Coastal Access – Humber Bridge to Easington

Representations on Humber Bridge to Easington and Natural England’s comments

March 2022

Natural England agrees with the proposed modification and asks that the Secretary of State approves our proposals with the modification described by Revised Map HBE 1a in Section 5 – Supporting Documents below.

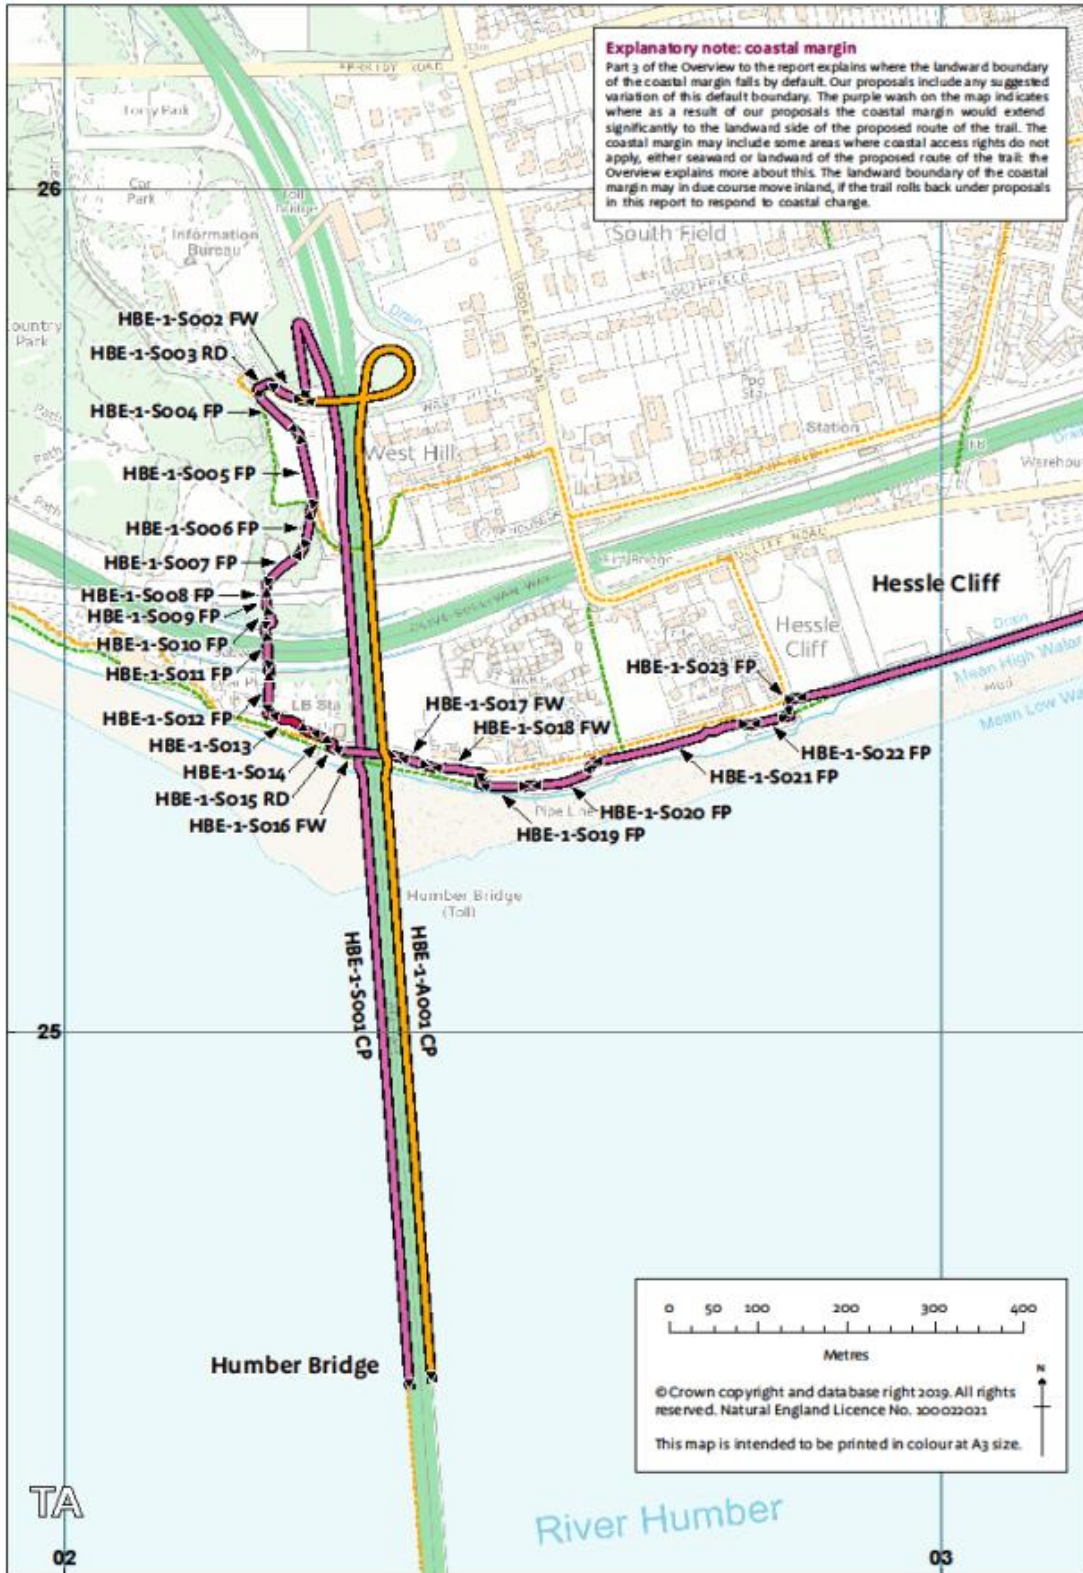
Proposes that Natural England work with East Riding of Yorkshire Council to remove existing steps where the proposed trail leaves the side of the estuary on the existing PROW/Trans Pennine Trail to join Livingston Road. This will enable a wider range of users to access the ECP and Trans Pennine Trail.
